REPORT
to
Working Group on Revision of Loading Guide C57.91

**Comparison of Calculated Hot Spot Temperatures
Using *CLAUSE 7* Equations versus *ANNEX G* Equations**

Glenn Swift, Tim Raymond
March 2004

Fig. 1(b)

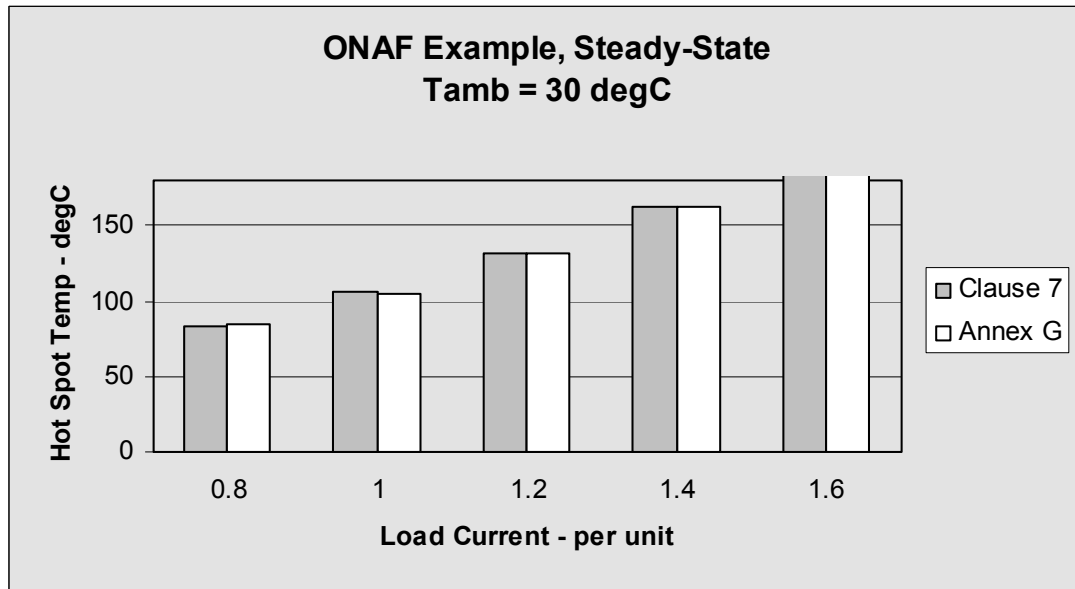
The two methods show good agreement up to a loading of 1.4 per unit. The graph is purposely truncated at a temperature of 180°C because tripping would certainly occur before that temperature is reached, making the accuracy irrelevant.

Fig. 1(d)

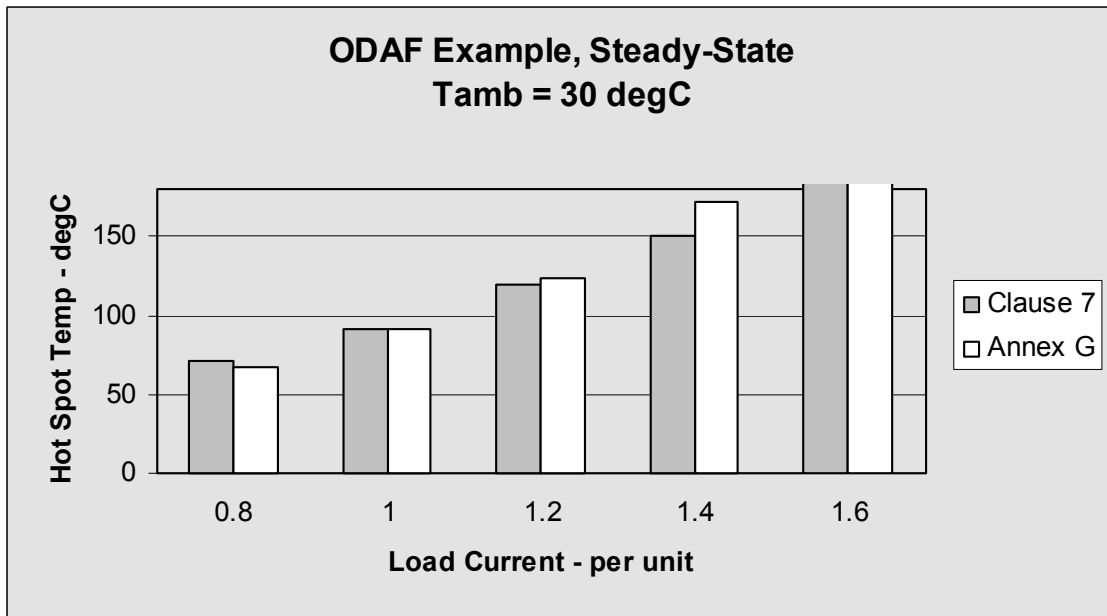
There is significant error at a loading of 1.4 per unit: 22°C. (Again, the graph is purposely truncated at 180°C.)

Fig. 2(d)

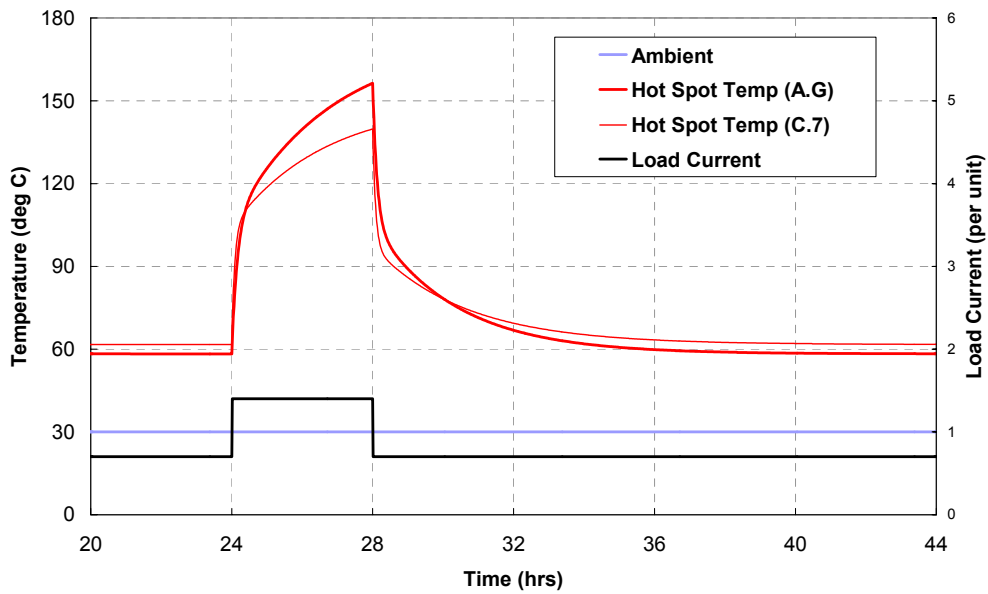
Again, a significant error of from zero to 15° during the rising transient period.

Fig. 3(b)

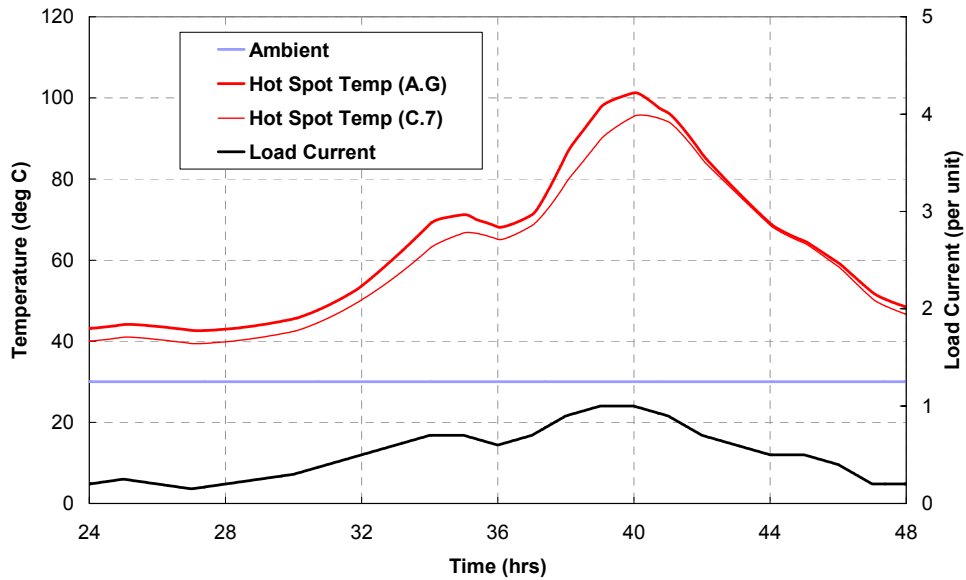
The maximum error is about 5°C.

Fig. 3(c)

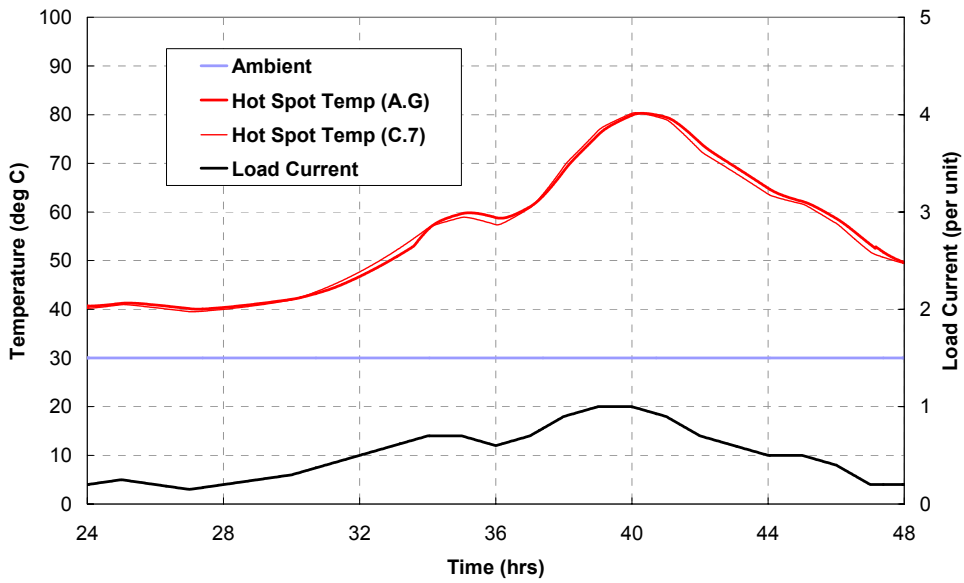
The error here is negligible.
